FLEX General Notes

MODIFYING THE MP-A PROCESSOR BOARD FOR FLEX 2.0

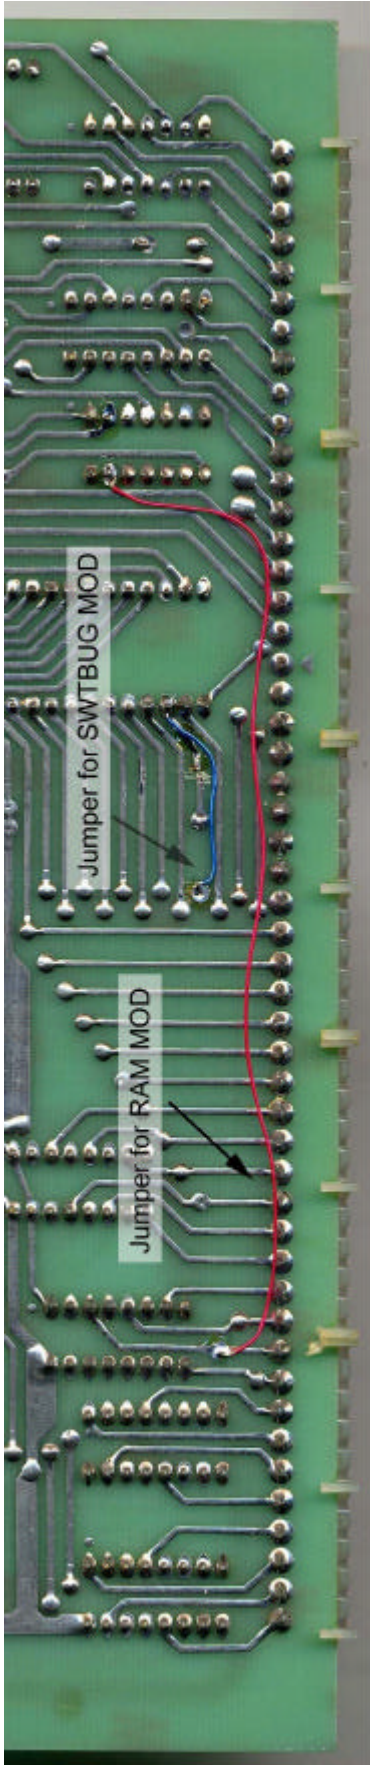
If your computer system is a SWTPc and has an MP-A (not MP-A2) processor board, you will have to modify it in order to use FLEX 2.0. The modification allows the CPU to access data from an external memory board rather than the on-board 6810 scratchpad RAM chip. This allows you to use external memory at A000 hex which is where FLEX resides.

- 1) Cut the foil trace connecting pin 10 to pin 13 of IC16 on the "TOP" side of the board. IC16 is a 7420 and is the third IC from the left on the bottom row as viewed from the "TOP" side.
- 2) Solder an insulated jumper from the now unconnected pin 13 of IC16 to pin 3 of IC7 on the "BOTTOM" side of the board. IC7 is a DM8097 or a 74367 and is the third IC from the right on the bottom row as viewed from the "TOP" side.
- 3) If you have put IC3 (the 6810 RAM chip) in a socket, simply unplug it. If it is soldered in place, it will be easier to disable it by cutting the foil trace connecting to pin 13 of IC3 on the "BOTTOM" side of the board. Next solder a jumper between pins 12 and 13 of IC3.

The processor board is now ready to be re-installed in your system. Note that the modified processor board will NOT FUNCTION at all without external memory at locations \$A000 thru \$A07F. This is because SWTBUG requires memory in that area. FLEX 2.0 will require memory from \$A000 thru \$BFFF.
